MFN 06-262
Supplement 4

Subject: **Modified Reactor Building/Fuel Building Truncated Model,
SER-ESB-038 Rev. 5**

**Shimizu Engineering Report SER-ESB-038, Rev. 5,
“Modified RBFB Truncated FE Model Analysis Data,”**

Project	General Electric Company ESBWR Project	Shimizu Document No.	SER-ESB-038
Title	Modified RBFB Truncated FE Model Analysis Data	Rev.	5
		Issued Date	9/22/06
		Revised Date	1/9/07

Figure C-15 Element Forces Comparison NASTRAN to ANSYS (R7 F1 Wall: Out-of-plane Shear [MN/m])

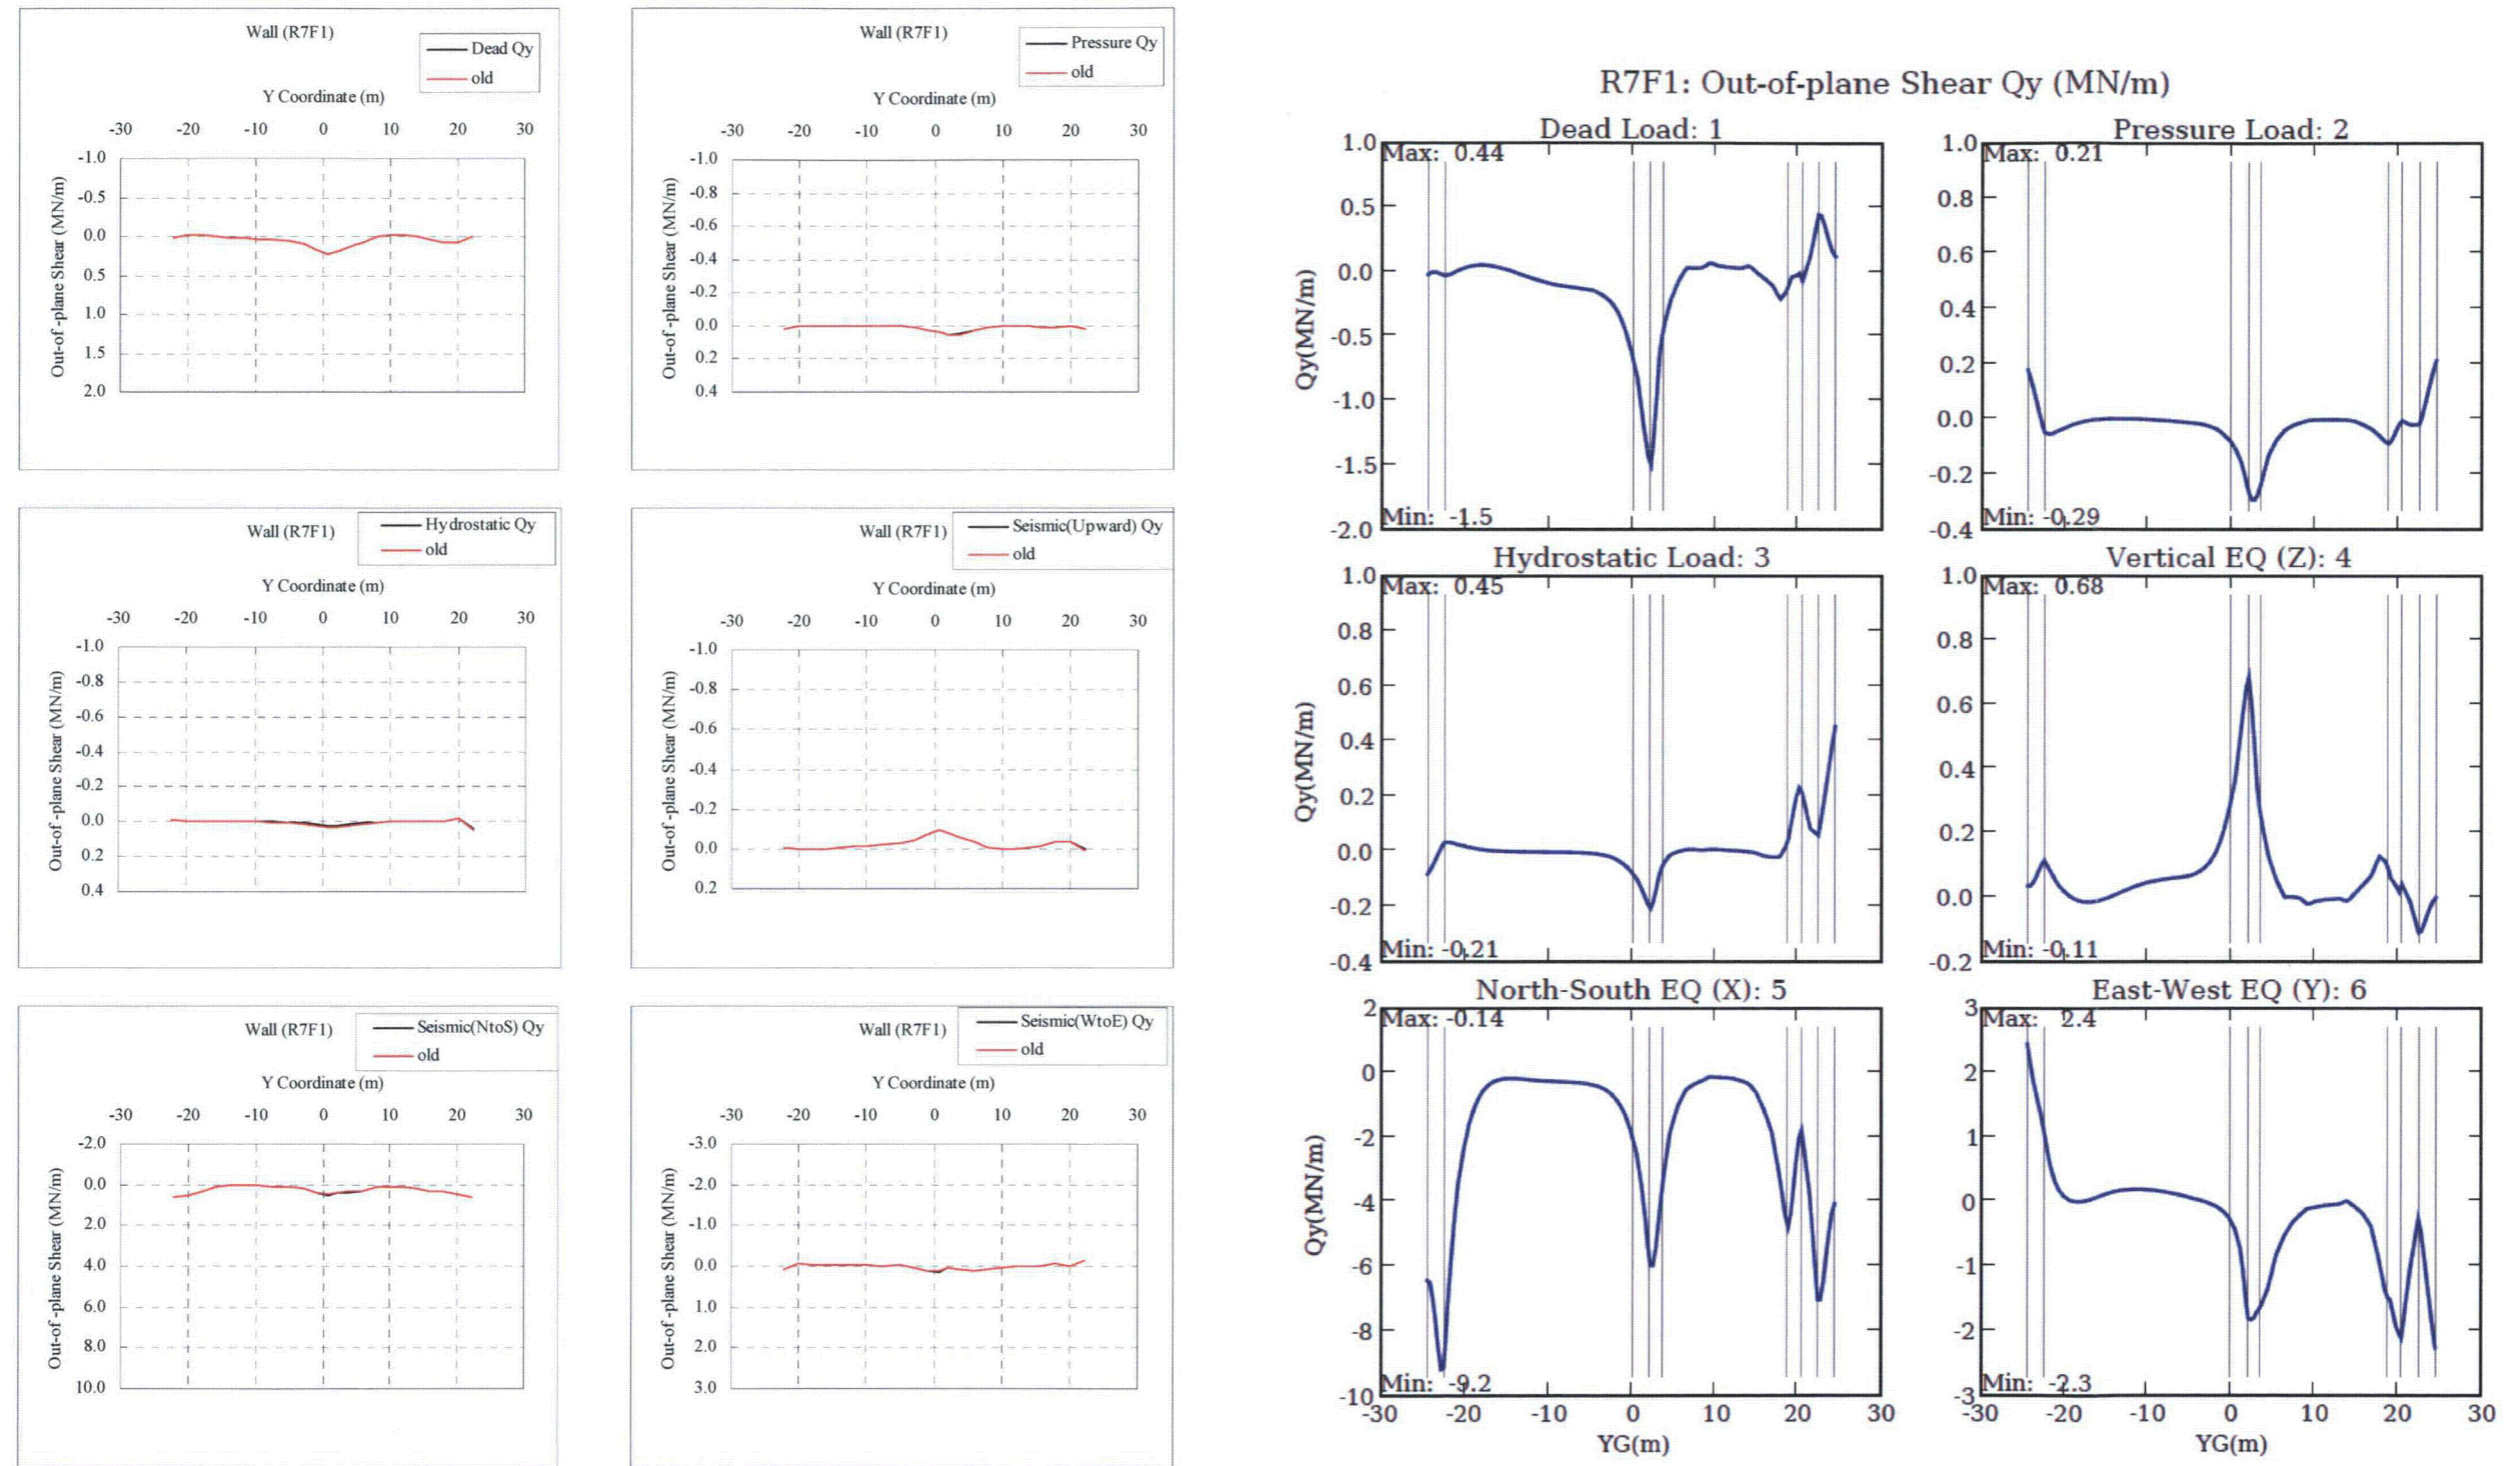
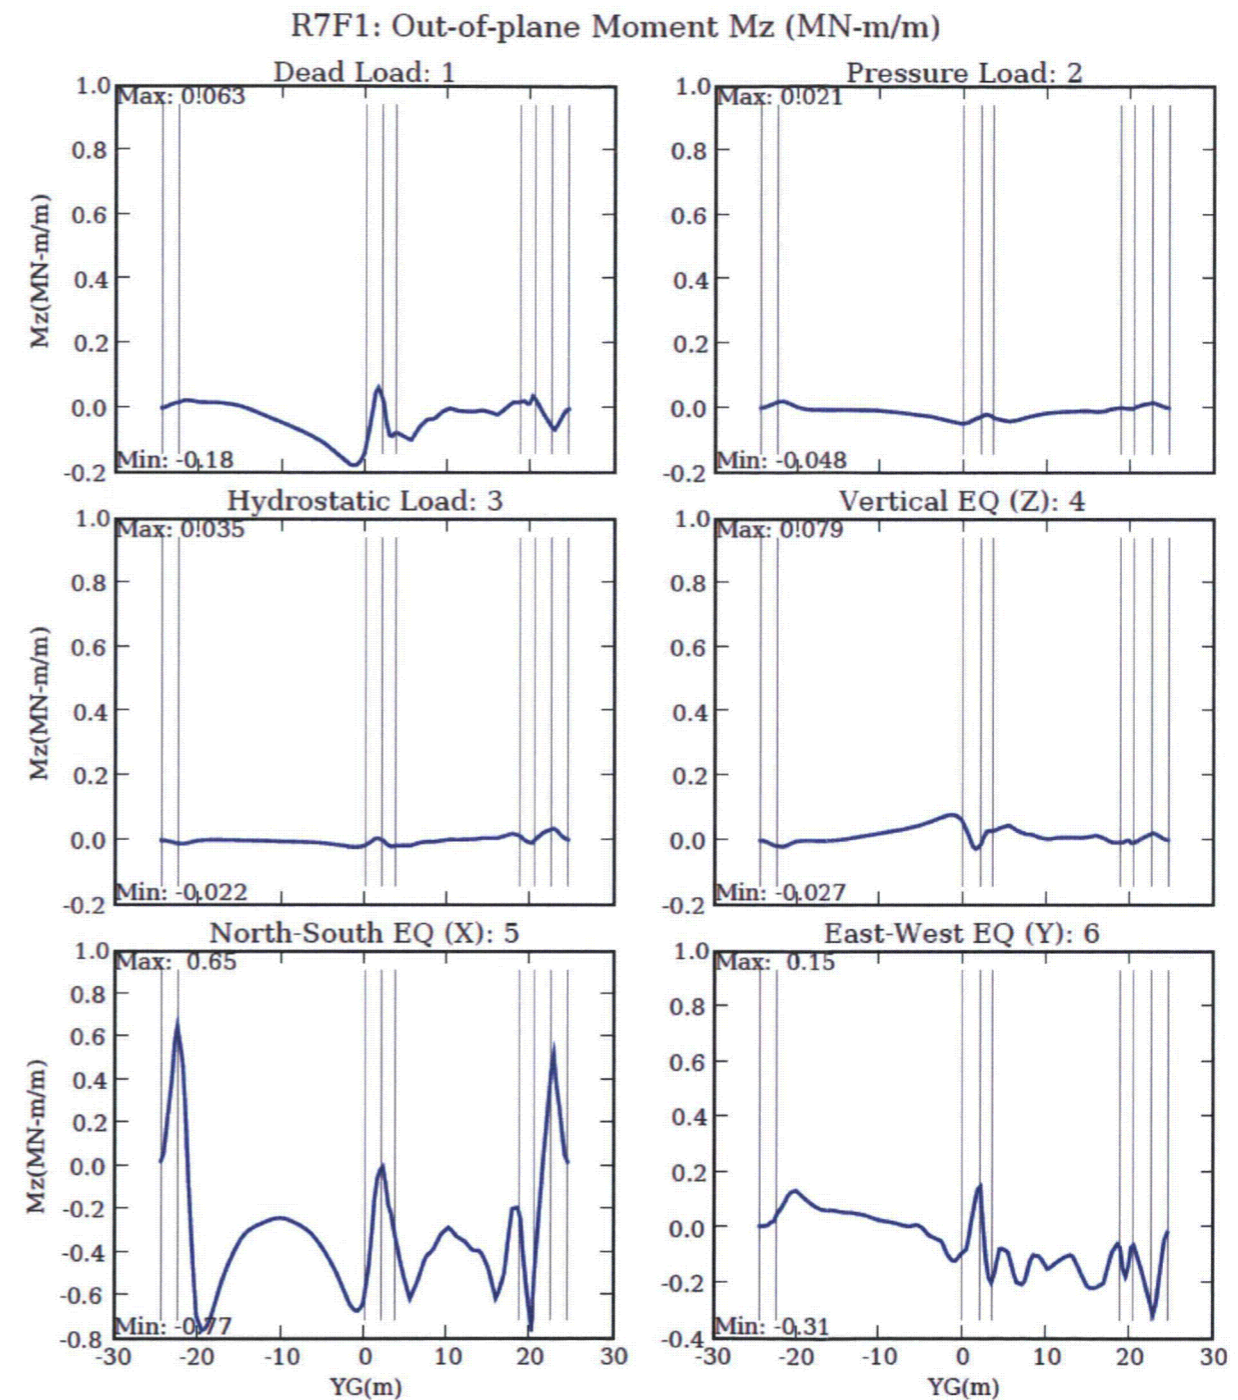
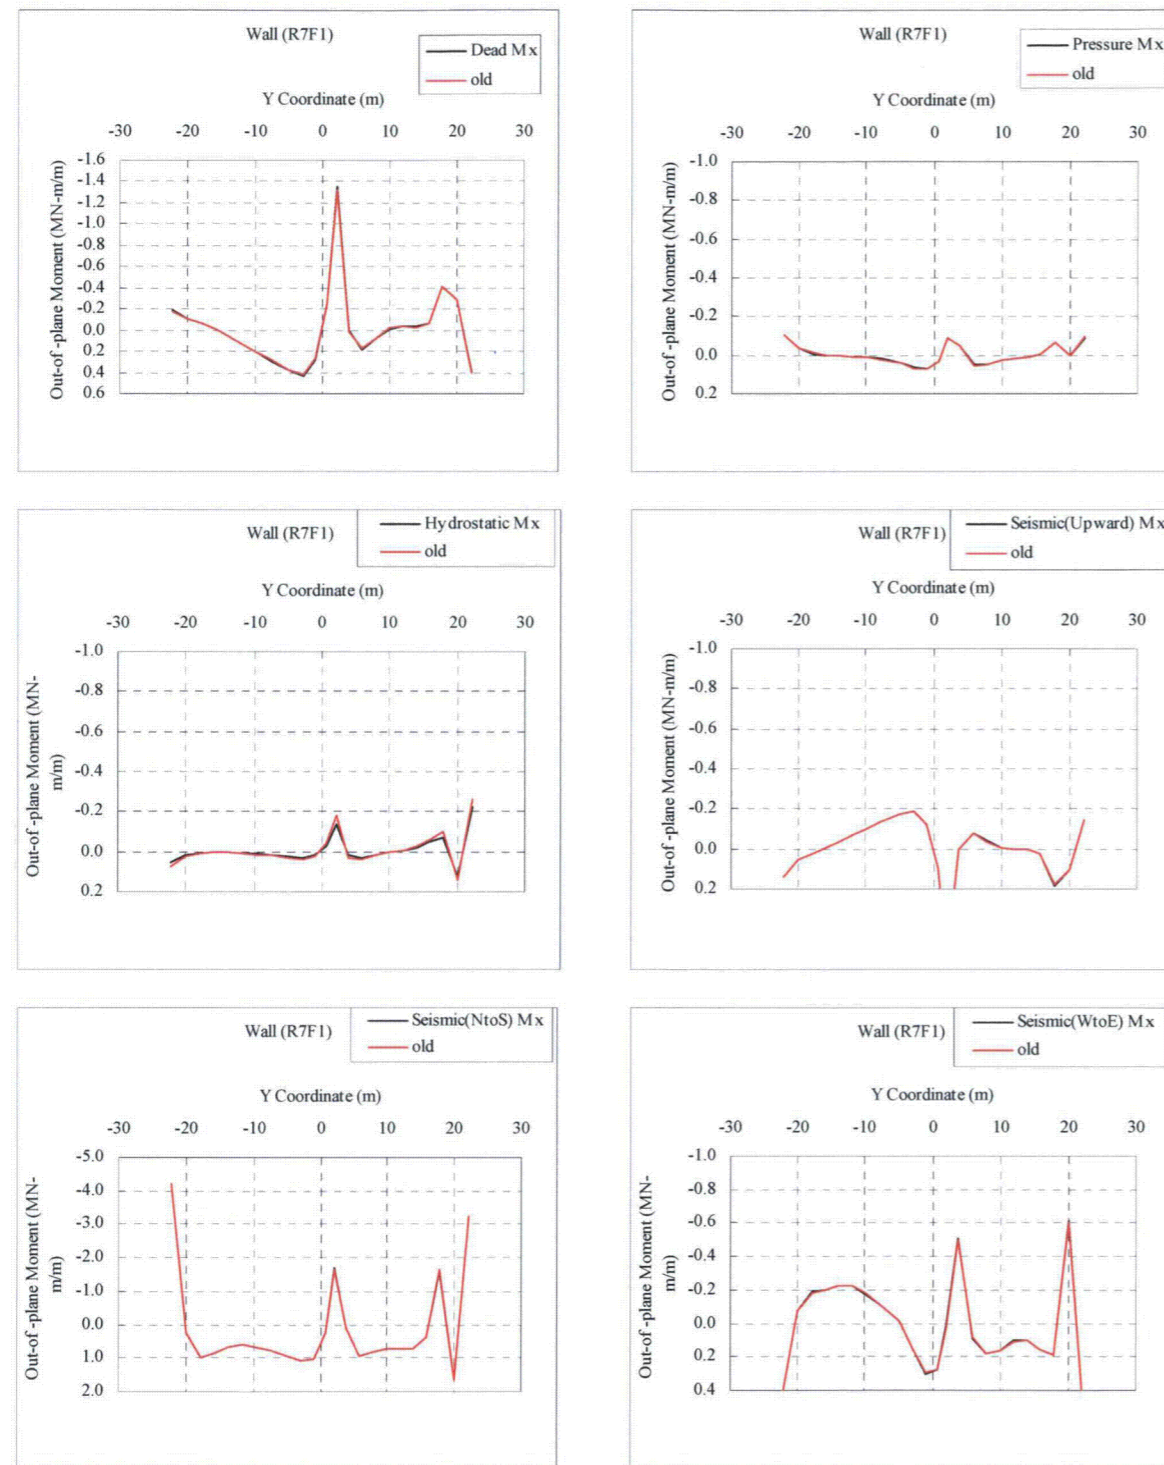
- iii) *The differences of magnitude of forces appeared on basemat inside pedestal:* The result of re-analysis using the updated model shows better agreement. In case of seismic load the magnitude of forces has to be re-compared because BNL's soil spring may not be adequate as pointed out above 3).

- iv) *The differences of magnitude of forces appeared on outer wall of Fuel Storage Pool (FSP):* For the out-of-plane shear forces and moments on RA and F3 wall located around FSP in case of Hydrostatic load, BNL's results are lower than those of GE. GE assumes the some part of differences comes from the difference of estimation levels between both models as pointed out above 8). In order to have a better understanding of the differences, GE would like to request BNL to confirm the input data for Hydrostatic load.
